STATE OF NORTH CAROLINA
DEPARTMENT OF TRANSPORTATION

Subject: **Application for the Modification to the Section 404 Individual Permit and Section 401 Water Quality Certification** for US 501 from NC 49 in Roxboro to SR 1602 (Jesse Banks Road) in Person County, Division 5. Federal Aid Project No. STP-501(11), WBS Element No. 34406.2.3, TIP No. R-2241A.

This permit modification request is for a revision to Site 7A. Attached is a revised permit drawings 17, 18, 47 and 48 of 48, and rock vane detail.

Permit Drawing 18 of 48
Revised 8/19/14

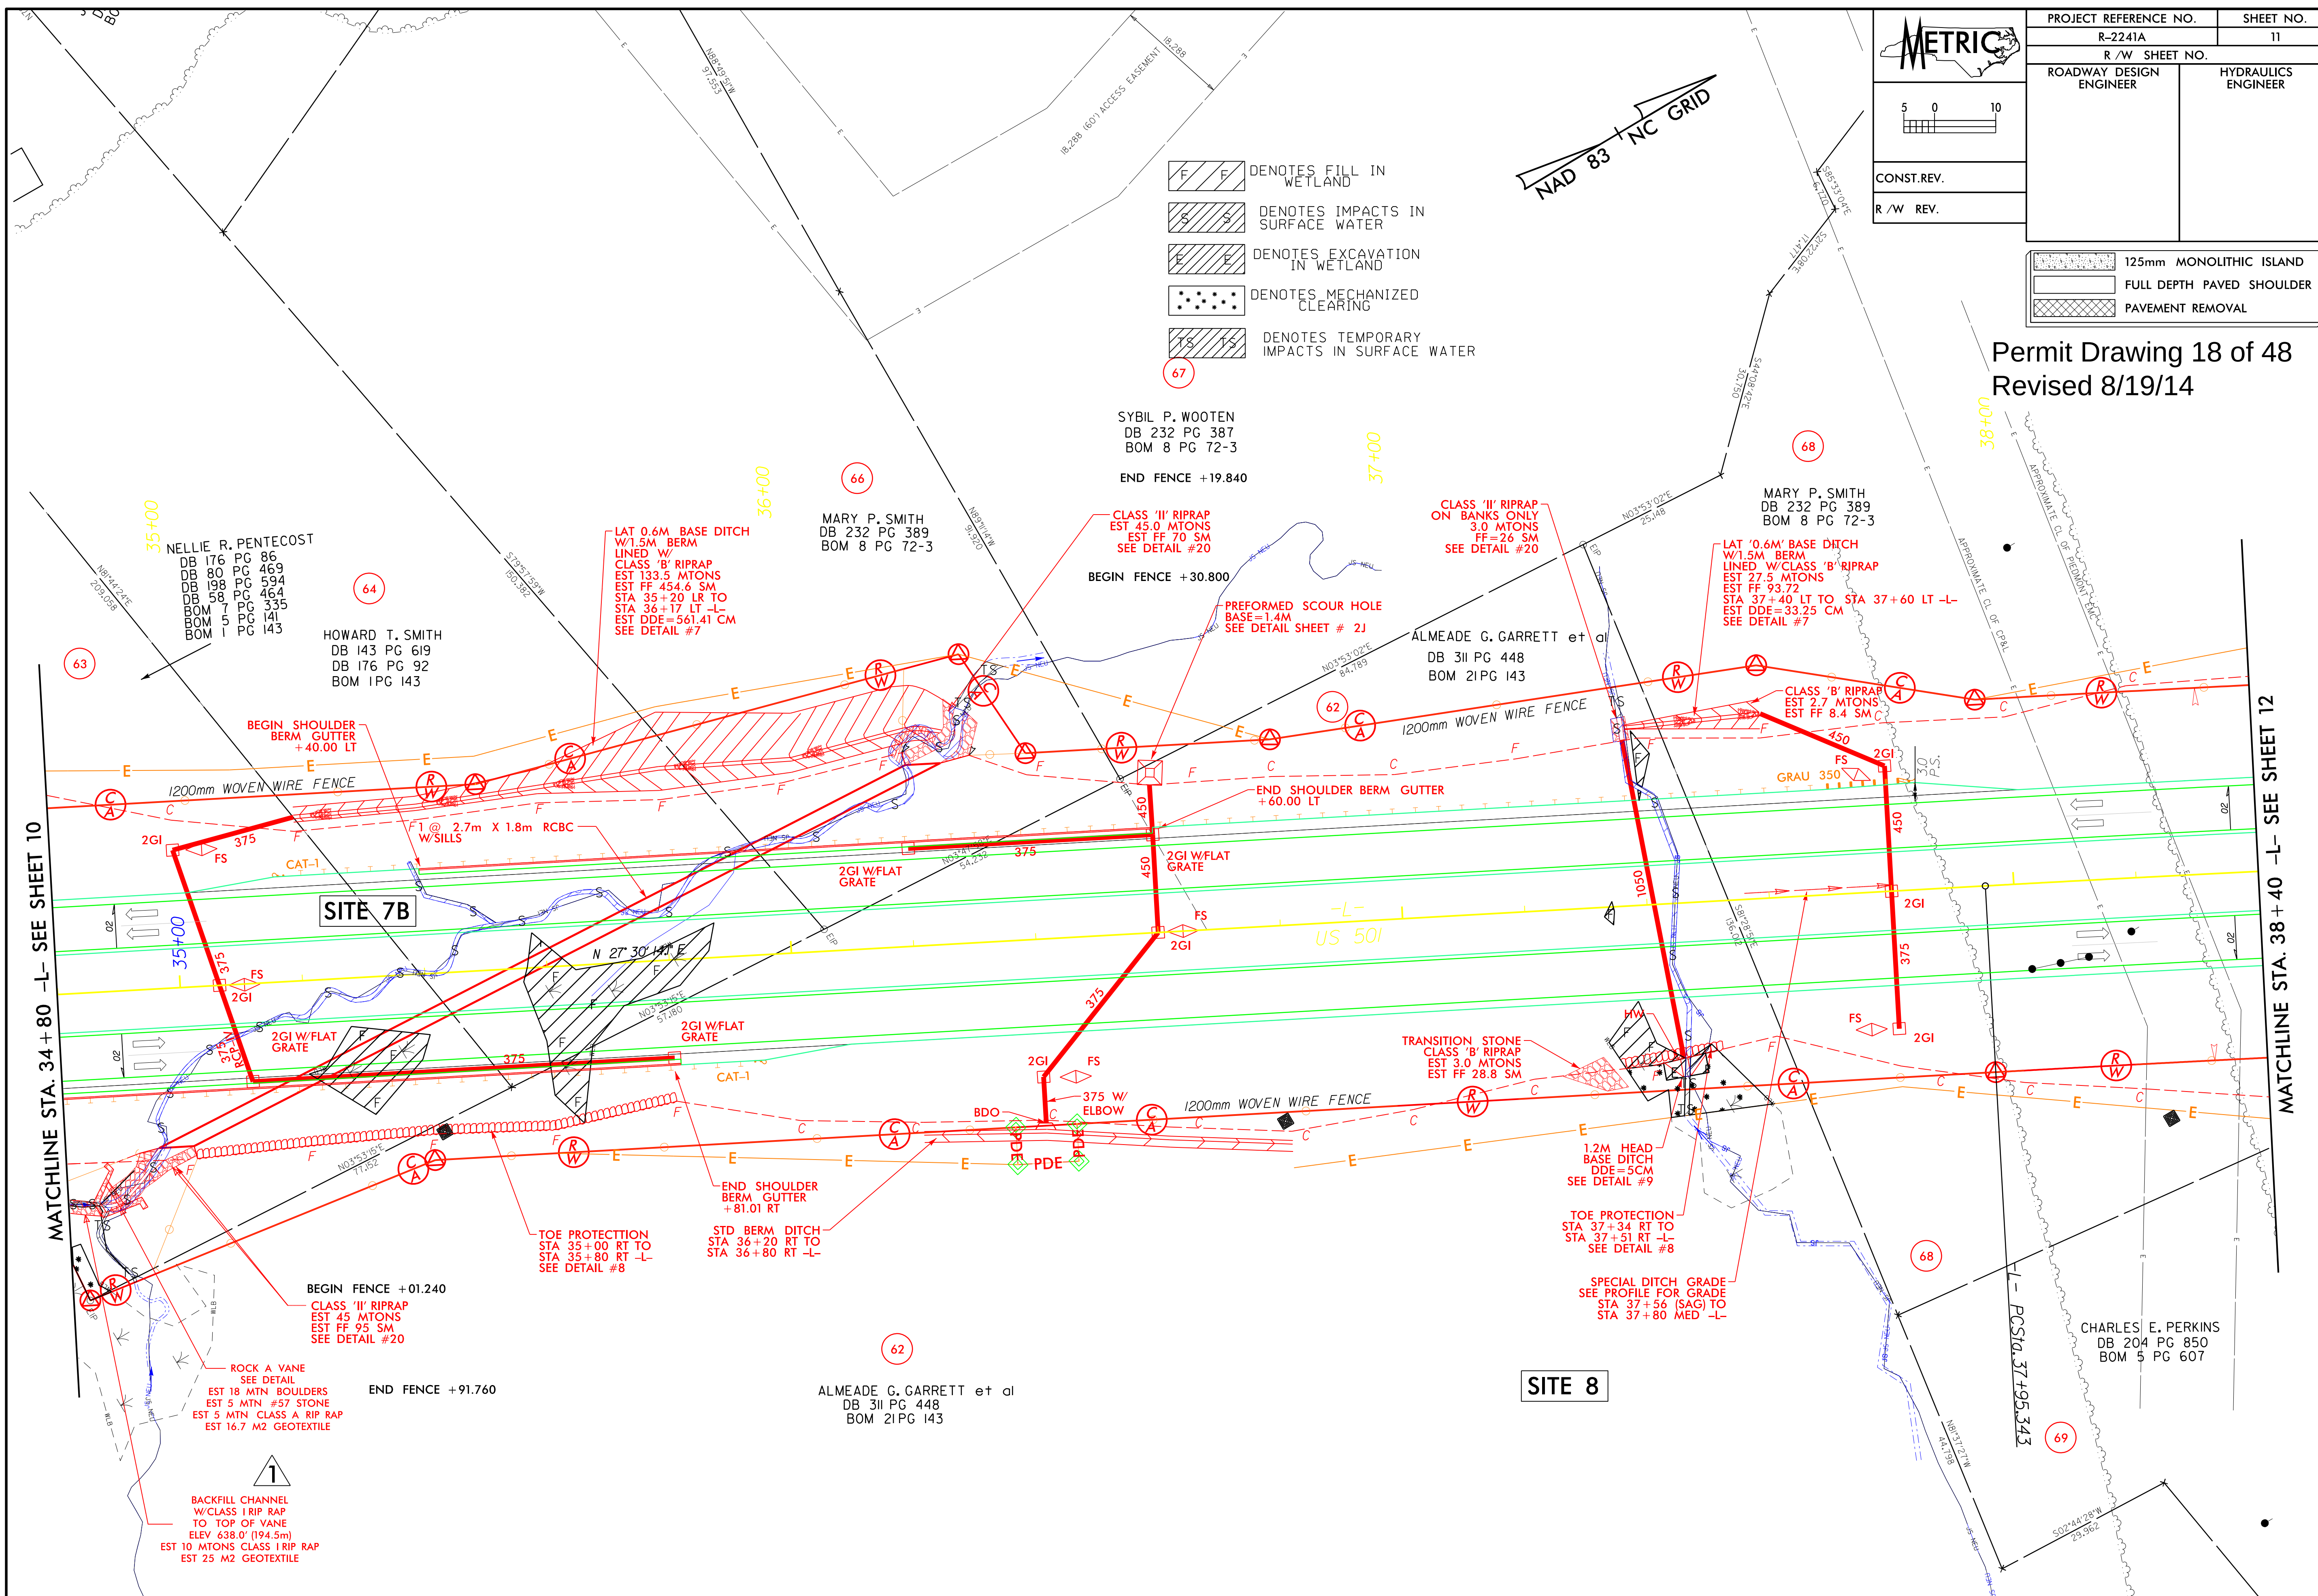
Following construction of the culvert at permit Site 7A, there are some stream stability issues on the inlet side of this structure. The streambed to the inlet side of the culvert has head cut significantly from its original elevation. It is obvious that the stream will not

stabilize naturally. Therefore, NCDOT proposes using a rock vane and backfilling of the existing stream channel to eliminate continued migration of the head cut upstream and to stabilize the portion of head cut that has taken place. Upstream of the box culvert is a main stream channel and tributary. It is proposed to set the rock vane at the confluence of these two channels. Presently the head cut continues upstream in the main channel approximately to the R/W line. It is proposed to backfill the portion upstream of the rock vane with Class I rip rap to reestablish and stabilize the bottom of channel. It is anticipated the voids in the rip rap will fill in with sediment/bed material over time. The tributary has yet to head cut and the rock vane should establish a boundary that prohibits any potential in the future.

Attached is a revised permit drawing, revised summary sheets, and rock vane detail. Changes to stream impacts are: **39ft of Temporary Stream Impact will now be Due to Addition of Rock Vane and backfill/stabilization with Class I rip rap in Main Channel.**

08-04-14 - ADDED ROCK VANE AT +/- STA.34+85 RT.
